BIDDING AND CONTRACT DOCUMENTS Section 00 21 15 – Addendum No. 1

SUBJECT: ADDENDUM NO. 1 TO THE BIDDING DOCUMENTS FOR

Roof Renovations Housing Authority Gallatin County 117 West Wilson Street Shawneetown, Gallatin County, Illinois 62984 HR: 390-1263

This addendum forms a part of the bidding and contract documents and modifies the bidding documents dated March 26, 2024. Acknowledge receipt of this addendum in space provided on Bid Form. FAILURE TO DO SO MAY SUBJECT BIDDER TO DISQUALIFICATION.

UNIT 8 -ROOF PLAN, ELEVATIONS, AND DETAILS

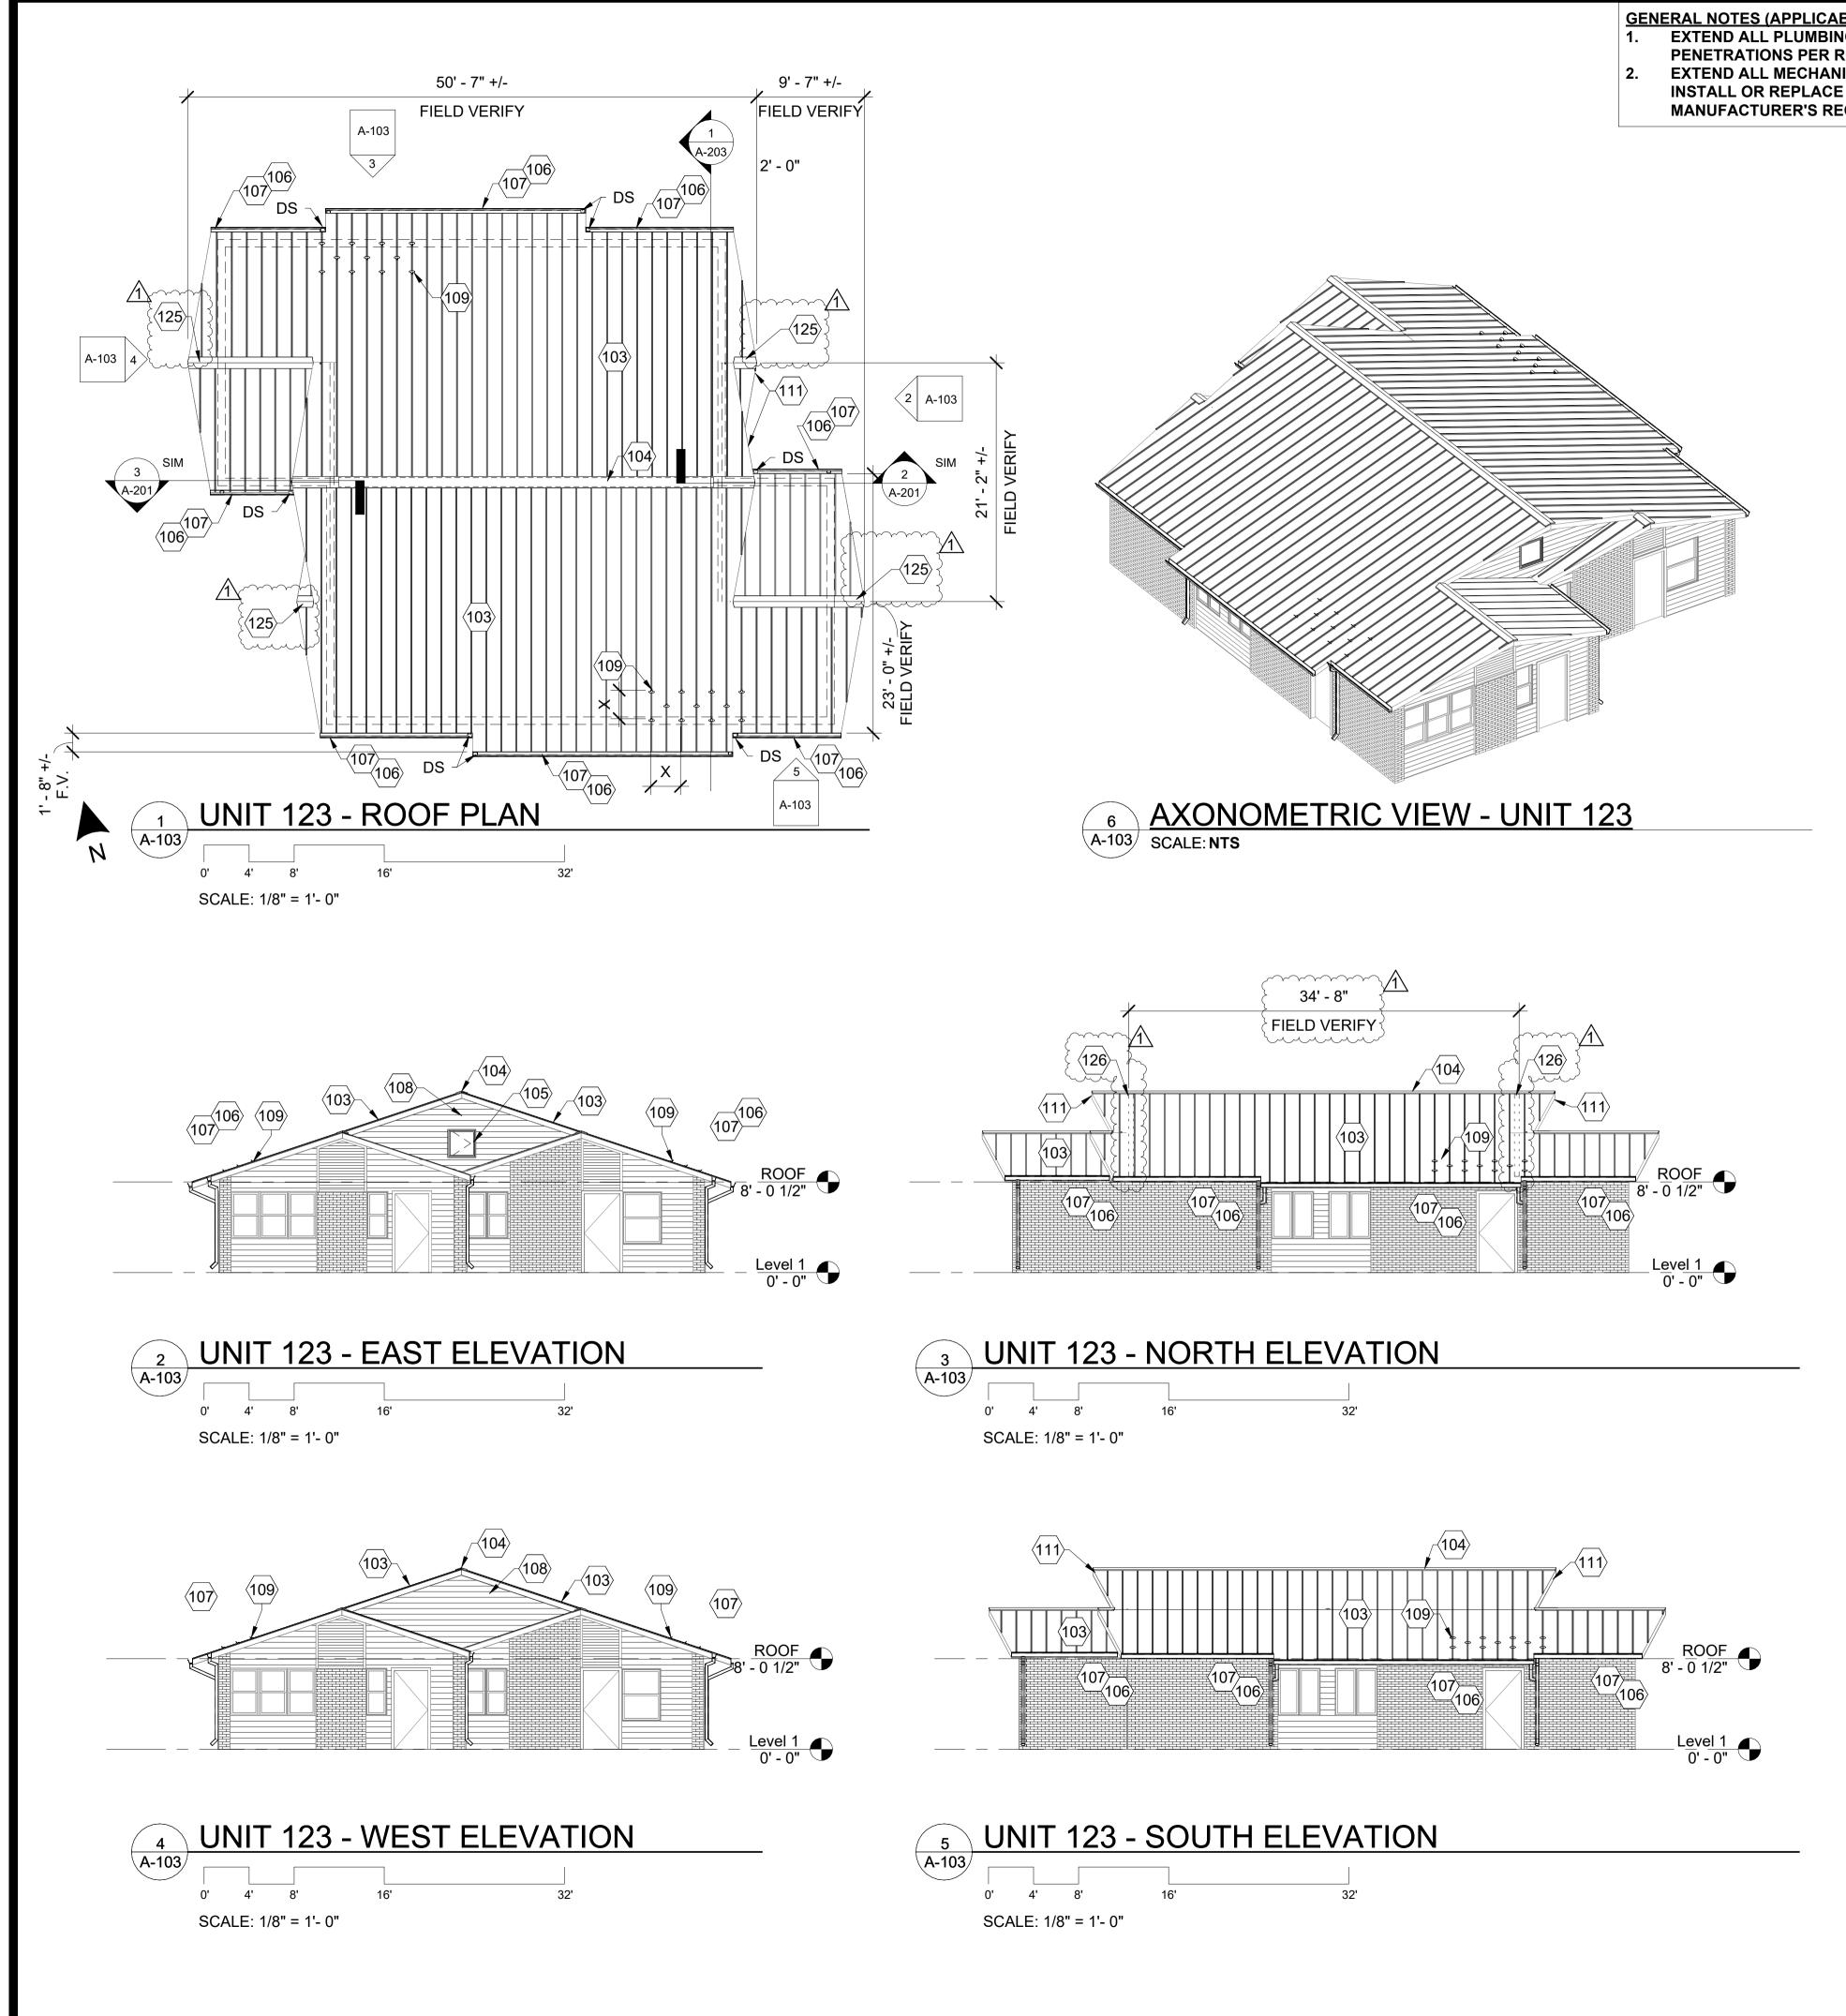
- 9. At Sheet A-102 (included), at Drawing 1, Roof Plan, see new note for sheet metal ridge cap. At Drawing 3, East Elevation, see note on new end walls including their location and the dimension between them (to be field verified locate per note).

A-103

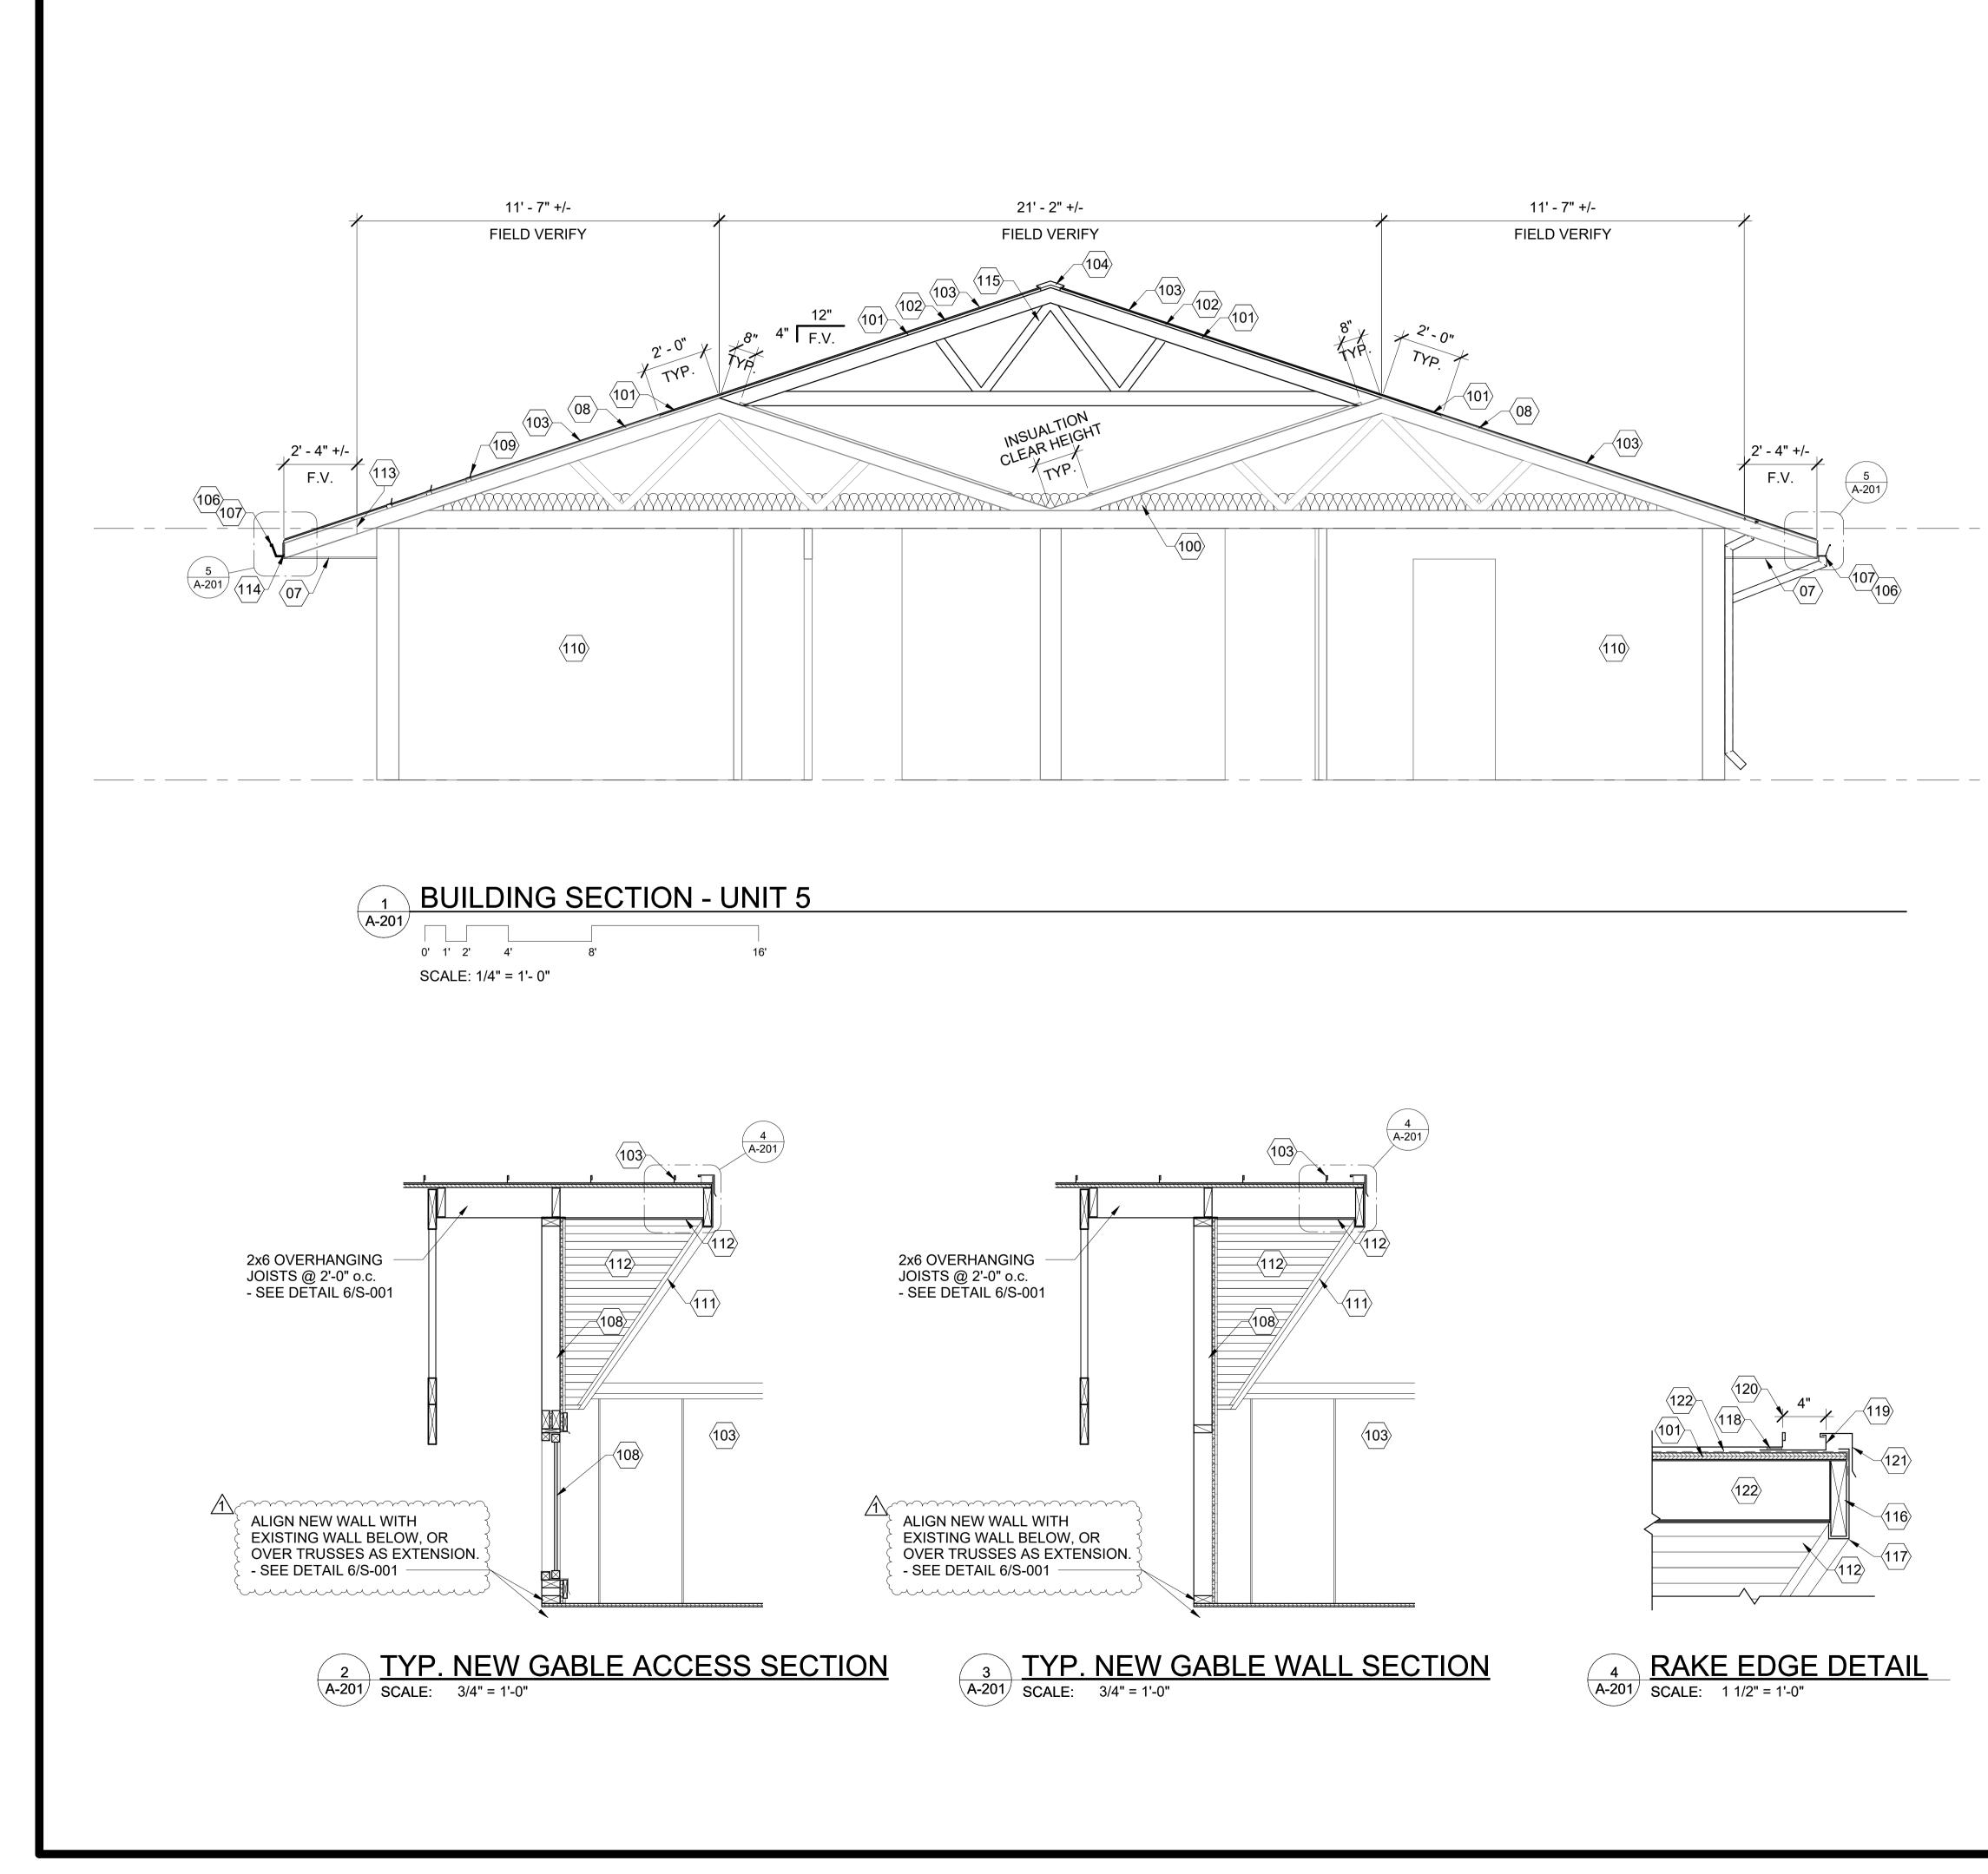
- 10. At Sheet A-103 (included), at Drawing 1, Roof Plan, see new note for sheet metal ridge cap. At Drawing 3, North Elevation, see note on new end walls including their location and the dimension between them (to be field verified locate per note).
